RE: Amendment to Site Certification PA 97-35
Gas Main Extension to PRIMEX Technologies, Inc.

Gas Main within
Purdom Plant

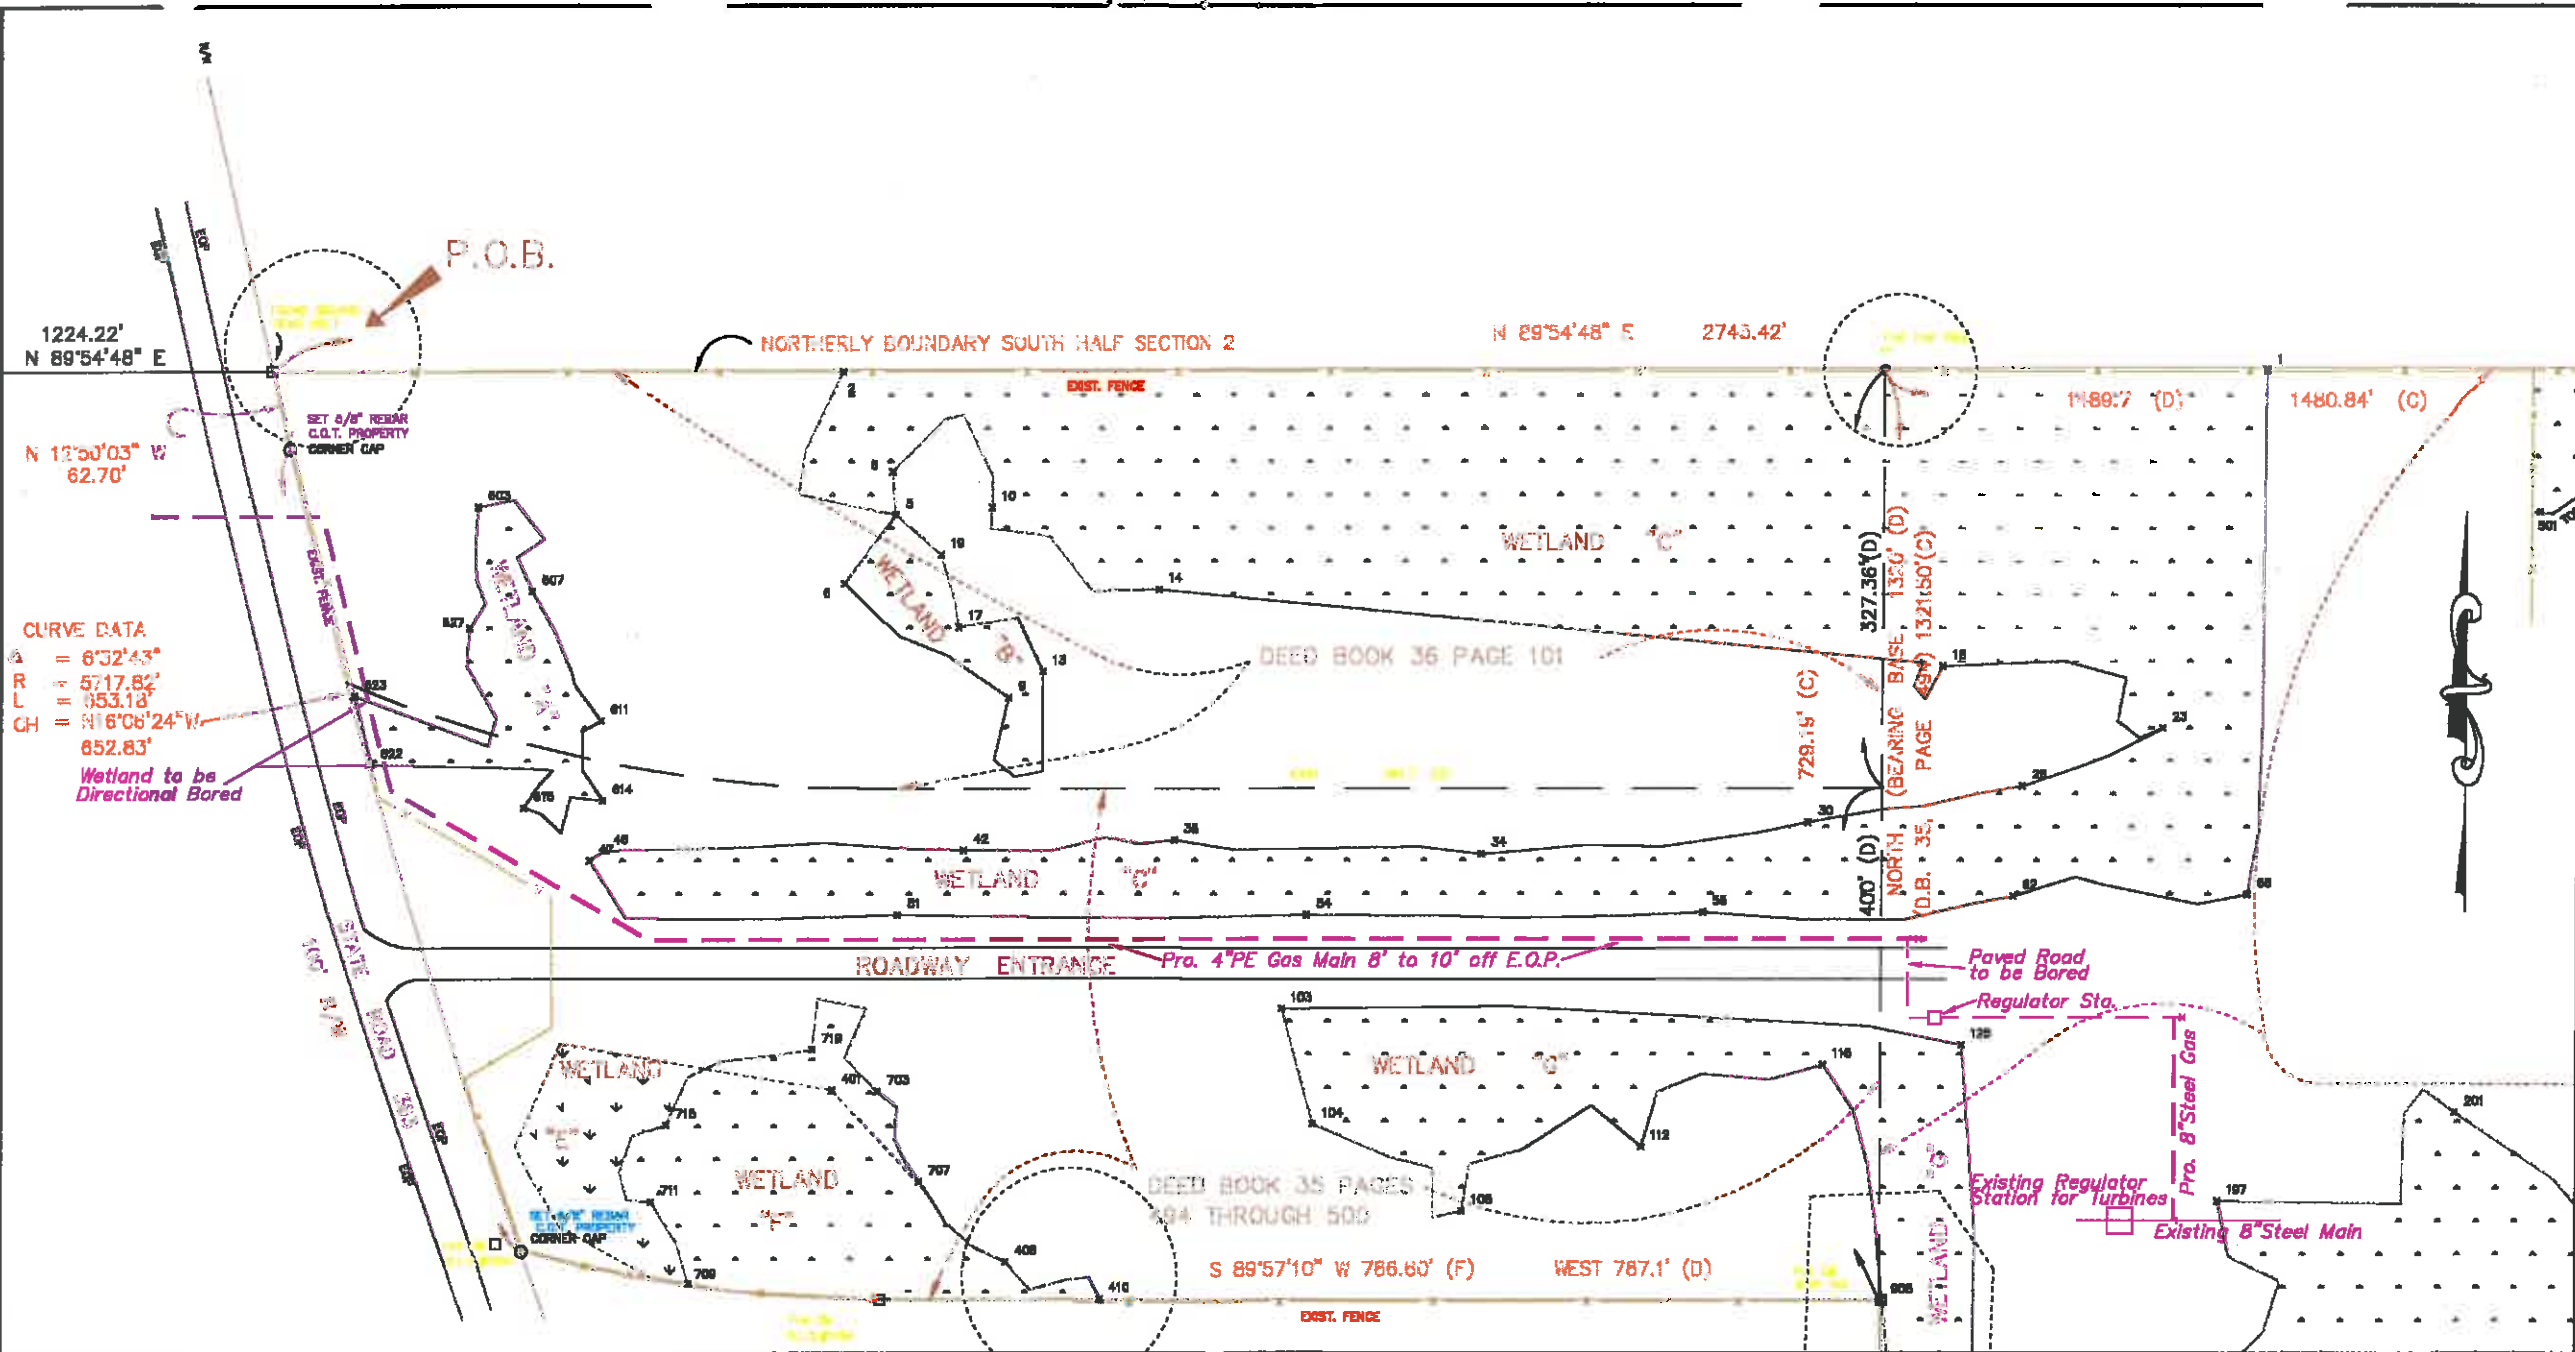
The proposed gas main extension will start at a point on the main gas feeder close to the Gas Turbine Units for the Purdom Station. An 8"x 8" steel tap and tee will be installed to make the new connection. Flanges will be installed on the east side of the tee to allow the east run to be abandoned at a later date. On the north side of the new 8"x 8" tee, Gas Operations will construct 160' of 8" coated steel gas main to approximately 35' south of the Station's Entrance Road.

At this point, an 8"x 8" tee, 8" valve and 8"x 4" reducer will be installed. The east leg of this tee will be capped with a blind flange to allow for future expansion. A 4" coated steel gas main will be extended west 190' to the south side of the old chlorine building, at which point a 10' x 10' regulating station will be constructed to reduce gas pressure from 200 psig to 60 psig. Once line pressure has been reduced at the regulating station, the proposed gas main will cross under the entrance road to the north. This portion of the gas main, 60 feet of 4" IPS Plastic Pipe, will be installed using the directional boring method.

Approximately 1100' of 4" polyethylene (PE) pipe will be constructed along the northern side of the main entrance road approximately eight to ten feet from the edge of pavement. Once the pipe reaches the perimeter fence along the west boundary of the property, another 400' of 4" PE pipe will be constructed north along the perimeter fence to the northwest corner of the site. Here a 90 degree bend will be installed, and the main will leave City property and be extended under State Road 363. The minimum depth for all constructed gas main will be 36 inches.

As we discussed in our meeting and as noted on the attached drawing, the City will not impact any DEP jurisdictional wetlands nor will any dewatering activities be required; therefore, minimal, if any impact to the environment is anticipated.

We are hereby requesting the Department to amend our Site Certification to include the new pipeline for PRIMEX Technologies, Inc. as noted in this letter and the attached amended site plan.
